DOCUMENT 00 90 00
ADDENDUM

ADDENDUM NO. [1] Date: March 12, 2020

**RE: LA CROSSE HOUSING AUTHORITY
2018-19 CAPITAL IMPROVEMENT PROJECTS-PHASE 2
1307 BADGER STREET
LA CROSSE, WI 54601
HSR PROJECT NO. 19032**

**FROM: HSR Associates, Inc
100 Milwaukee Street
La Crosse, WI 54603
(608) 784-1830**

C050

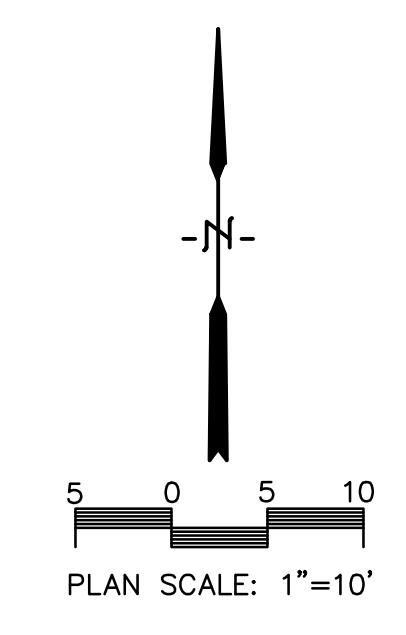
1. Sheet C050 DEMOLITION PLAN 30 x 42 attached hereto
 - a. Revisions clouded on Drawing.
2. Sheet C100 SITE PLAN - SOLBERG HEIGHTS 30 x 42 attached hereto
 - a. Revisions clouded on Drawing.
 - b. Refer to attached light fixture schedule, photo examples and pole base details for parking lot lighting.
3. Sheet A100 SITE PLAN – SCHUH HOMES
 - a. General Note C, revise peephole note to read as follows: “All doors shall have one peep hole. Accessible unit front doors shall have (2) peep holes. Accessible unit locations indicated by Key Note 2.
4. 8 ½ x 11 SCHEDULE/DETAILS AND PICTURES OF NEW LIGHT POLES.
 - a. Drawings attached hereto as part of Contract Documents.
5. Sheet A200 FLOOR PLAN – SAUBER MANOR
 - a. The exterior wall panels contain asbestos and shall be removed by the Owner under a separate contract.
 - b. Window Types A and B shall have GLT 12 in lieu of 13.
